**RE: Proposed M7 billboard signage - DA No. 60.1/2013  
Response to letter from Fairfield City Council dated 16 April 2013**

**RE: DEVELOPMENT APPLICATION NO. 60.1/2013  
4 x ILLUMINATED ADVERTISING STRUCTURES**

**Development Application Number 60/2013: Proposed construction of advertising structures adjacent to the M7 Motorway.**

Photo 3

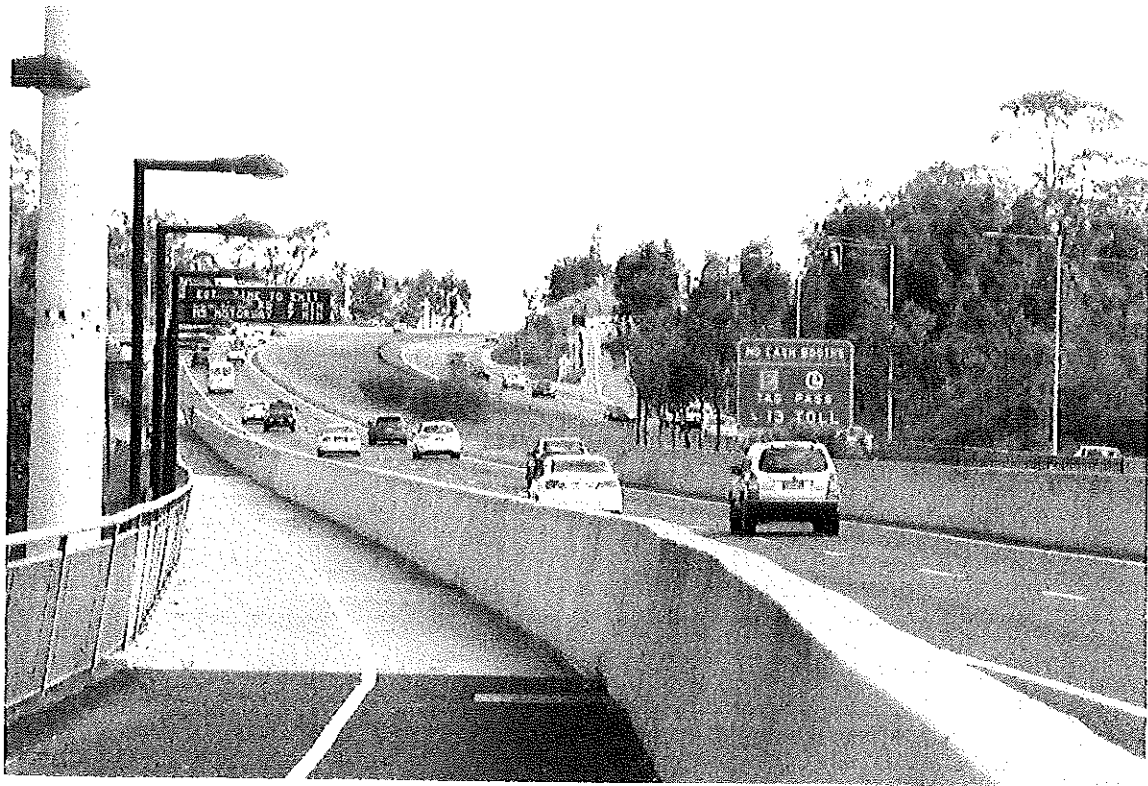
We have conducted a research of our own in regards to the billboard and have found the location that has been selected, in our opinion to be ridiculous.

As you can see from the photos we have taken attached, trees will need to be torn down to make room for the Billboard.

Then directly in line with the billboard are the 2 concrete electric posts that will interfere with drivers when trying to read your sign at one point or another, causing the driver unnecessary distraction.

Also, from the photos you will note that within seconds of reading your billboard drivers will also have to note the following signs:

1. The Etag sign to their right
2. Then to the left and above the electric flashing info sign
3. Then to their left again an exit sign to exit to Elizabeth drive

- i. The issues raised by the resident were addressed in the visual impact assessment that supported the DA. These issues are addressed further below.
- ii. The RMS does not object to the sign on traffic safety grounds.

- iii. Proposed Sign 4 is a single sided spectacular sign with visual display area orientated northward away from the residence. The sign will only be front lit, facilitated by lights fixed to the top of the sign that are oriented downward so that they only illuminate the front of the sign. Therefore the illuminated part of the sign will not be visible from the residence.
- iv. The Site Access Plan for Sign 4 clearly shows the proposed access route to the site which is away from the residential property. Therefore maintenance workers will not access the site from the residential property boundary.

Proposed Sign 4 is situated 155m north of the objecting residence. We provide an extract at **Attachment C** from the design package of Site 4 – Visual Impact that formed part of the DA. This shows that there are intervening trees and other existing vegetation which will separate the sign from the existing residence. The colour of the support frame and post for the sign is “River Gum” or similar, which is a natural colour that will allow the sign supports and the rear of the sign to visually recede/blend into its landscaped surroundings.
